UNITED STATES  
DEPARTMENT OF THE INTERIOR  
BUREAU OF LAND MANAGEMENT

1. Type of Well <input checked="" type="checkbox"/> Oil Well <input type="checkbox"/> Gas Well <input type="checkbox"/> Other	8. Well Name and No. JACKSON A 36
2. Name of Operator BURNETT OIL CO., INC.	9. API Well No. 30-015-35284
3a. Address BURNETT PLAZA - SUITE 1500 801 CHERRY STREET FORT WORTH, TX 76102	3b. Phone No. (include area code) 817-382-5081 FAX: 817-382-6102
4. Location of Well (Footage, Sec., T., R., M., or Survey Description) Sec 13 T17S R30E Mer NMP 740FSL 1750FEL	10. Field and Pool, or Exploratory CEDAR LAKE GLORIETA YESO
	11. County or Parish, and State EDDY COUNTY COUNTY, NM

**Jackson A 36**  
**30-015-35284**  
**Burnett Oil Co., Inc.**  
**August 09, 2013**  
**Conditions of Approval**

Proposed in Red

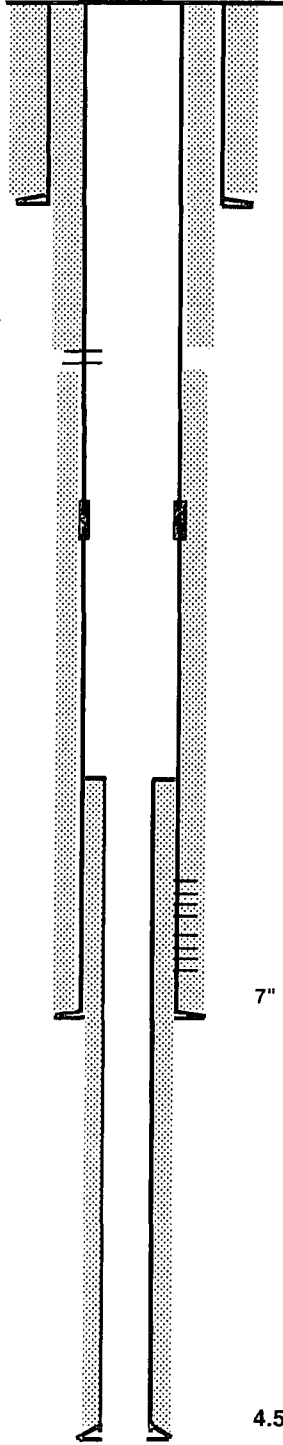
Burnett respectfully request a change to the depth on the original APD. We would like to deepen the Jackson A 36 well to the base of the Yeso near 6100? TVD. The well is currently 5250? deep with 7? casing and is producing from the Paddock interval only. Prior to deepening the well, the 32 Paddock perfs will be cement squeezed with 150 sx cmt. Based on Burnett's Blinbry completions offset to this well, it is anticipated to be a very economic re-entry with 2-3 slick water frac stages in the new hole. A 6 1/8? bit will be used for the new hole and 4.5? 11.60# L-80 casing will be run to TD and cemented with 200 sx cmt. A cement bond log will be run in the 4.5? casing prior to any Blinbry completions. A packer type liner hanger will be set at approximately 4400?, which is 277? above the top perf in the Paddock. After production data is gathered from the Blinbry, the Paddock will be re-stimulated with a slick water frac. Please also see the proposed well bore diagram for this well.

RECEIVED  
AUG 13 2013SEE ATTACHED FOR  
CONDITIONS OF APPROVAL4.5" 11.60# L-80 LTC per Brady Sullivan 180sx 1.48 Ft<sup>3</sup>/sx per attached e-mail.

1. Operator shall squeeze as proposed.
2. After squeeze operator shall test casing per Onshore Order 2.III.B.1.h. Submit results to BLM.
3. Surface disturbance beyond the existing pad requires prior approval.

6. If cement does not circulate to DV tool, the appropriate BLM office is to be notified.
7. Test casing as per Onshore Order 2.III.B.1.h. Submit results to BLM.

8. Before casing or a liner is added or replaced, prior BLM approval of the design is required. Use notice of intent Form 3160-5.
9. All waste (i.e. drilling fluids, trash, salts, chemicals, sewage, gray water, etc.) created as a result of work over operations shall be safely contained and disposed of properly at a waste disposal facility. No waste material or fluid shall be disposed of on the well location or surrounding area. Porto-johns and trash containers will be on-location during fracturing operations or any other crew-intensive operations.
